AFMV - Application for Minor Variation to an Existing Building Consent

BUILDING CONSENT NUMBER	BC260155

MINOR VARIATION 01

NORTHLAKE HOUSE.
ADDRESS: LOT 5007 (LOT 23)
NORTHLAKE, WANAKA N.Z 9305
CLIENT: JAMES WORKER

A5

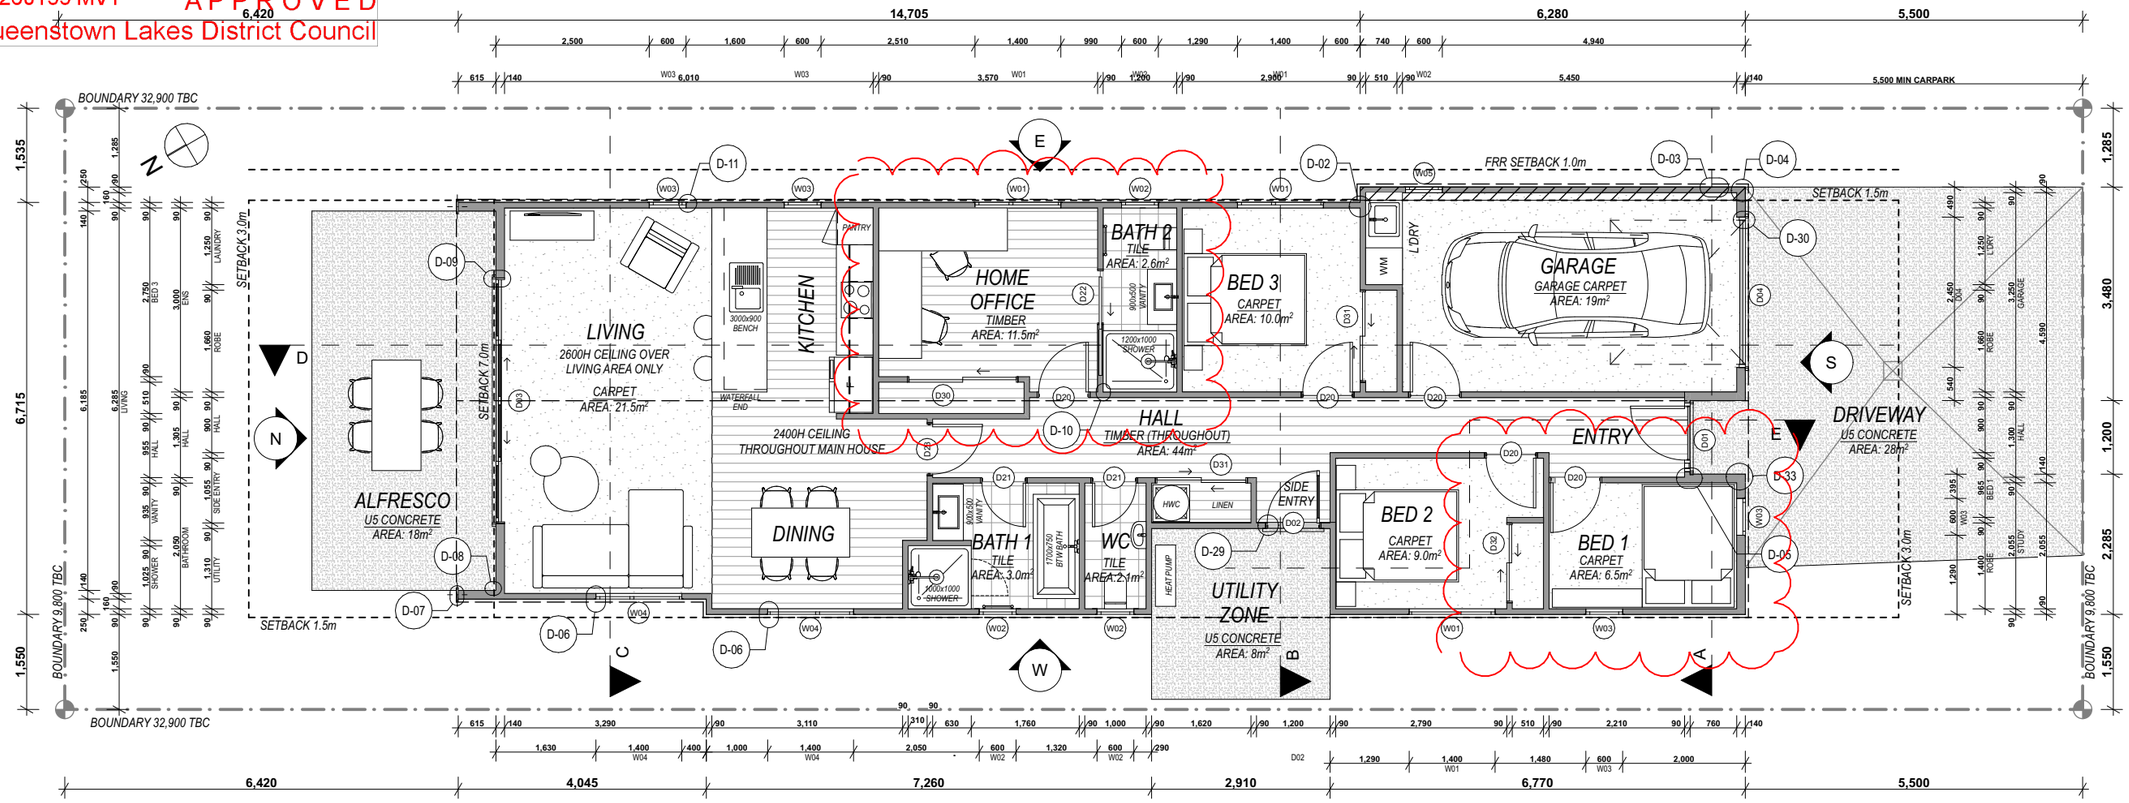
Amendment to room Layouts to satisfy section 37 – altered proposal bedroom 1 outlook: rule: District plan rule ODP 12.34.4.1.xi now satisfied.
Please refer to precedent plans accepted for houses at lot 5009, 5010 and 5011 up the street on Malvern Road.

Room name changes does not affect compliance
